**PLANNED UNIT DEVELOPMENT
STAFF REPORT****Date: May 6, 2004**

DEVELOPMENT NAME Western Hills Subdivision, Resubdivision of Lots 8 & 9, Block 4

REMARKS The applicant is requesting a revised Planned Unit Development approval to construct 40 attached, residential condominiums, on a single- building site.

SITE PLAN

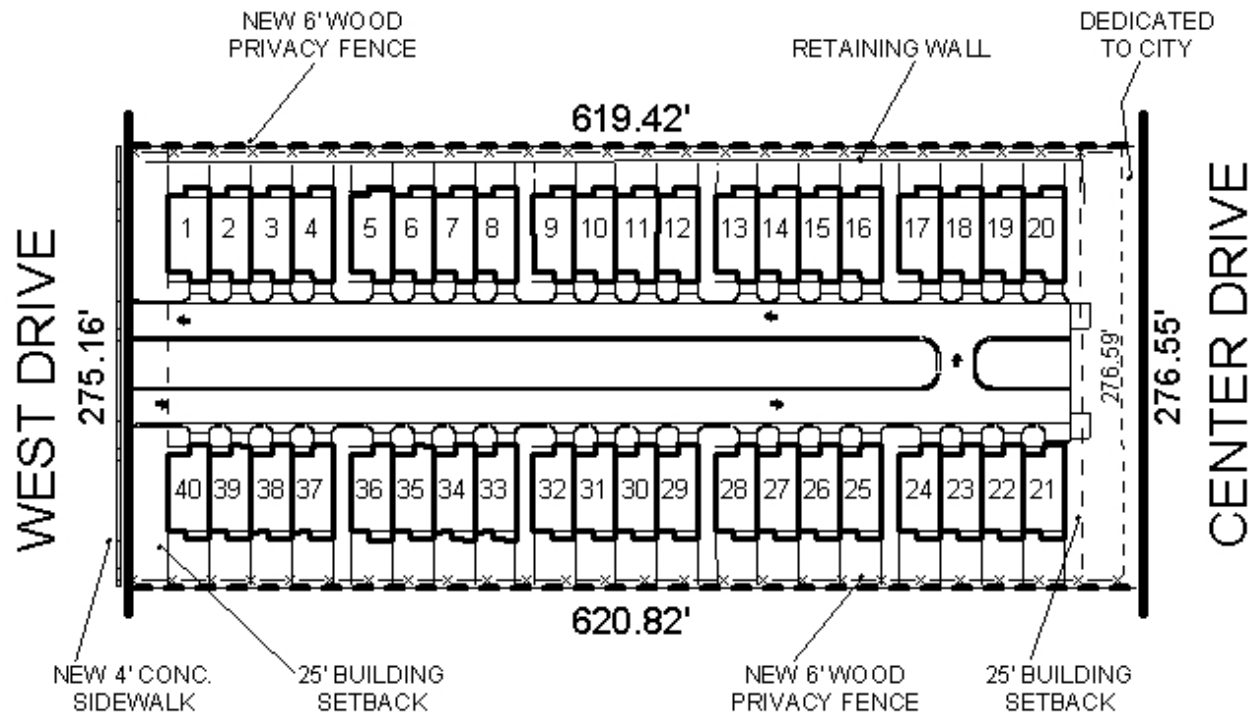
The only change pertains to parking. The January 2004 site plan illustrated angled parking along the one-way drives. The applicant now proposes a wider median, and parallel parking along the drive. Each unit will have a garage with on-street parking for visitors. The Zoning Ordinance requires 1.5 parking spaces per dwelling unit; a total of 84 parking spaces are provided, which includes the 40 garage spaces, thus complying with the parking requirements of the Ordinance.

The site actually fronts two streets, West Drive an improved public street, and Center Drive, a dirt road with a substandard width right-of-way. The dedication of the necessary right of way to provide 25-feet from the centerline of Center Drive was provided on the final plat, as well as the placement of a note on the final subdivision plat which states that access to Center Drive is denied until Center Drive is constructed to city standards.

However, the dumpsters along Center Drive are located within the 25-foot front yard setback. The Zoning Ordinance prohibits dumpsters in the front yard; therefore, the dumpsters should be relocated outside of the required front yard and in an area where adequate maneuvering area is provided. The location should be coordinated with and approved by Urban Development staff and Traffic Engineering.

It should be noted that the buildings are spaced 10-feet apart. The PUD Section of the Zoning Ordinance, establishes minimum spacing requirements between buildings (V.C.2,b.(1)), and in the case of buildings less than 20-feet apart, windows are not allowed.

Whereas the development will consist entirely of new construction, full compliance with the landscaping and tree planting requirements of the Ordinance is required. Additionally, the site adjoins detached, single-family dwellings to the North and South; therefore, the provision of a six-foot wooden privacy fence along the North and South property lines should be required.

Planned Unit Development: Based upon the preceding, this application is recommended for approval subject to the following conditions: 1) relocation of the proposed dumpsters outside of the required front yard, in an area where adequate maneuvering area for garbage trucks is provided, location to be coordinated with and approved by Urban Development staff and Traffic Engineering; 2) full compliance with the landscaping and tree planting requirements of the Ordinance; 3) that there be no windows facing buildings less than 20-feet apart; 4) provision of a six-foot wooden privacy fence along the North and South property lines; 5) denial of access to Center Drive until such time that Center Drive is constructed to city standards; 6) that the one-way drives be signed and marked according to MUTCD standards; and 7) full compliance with all municipal codes and ordinances.
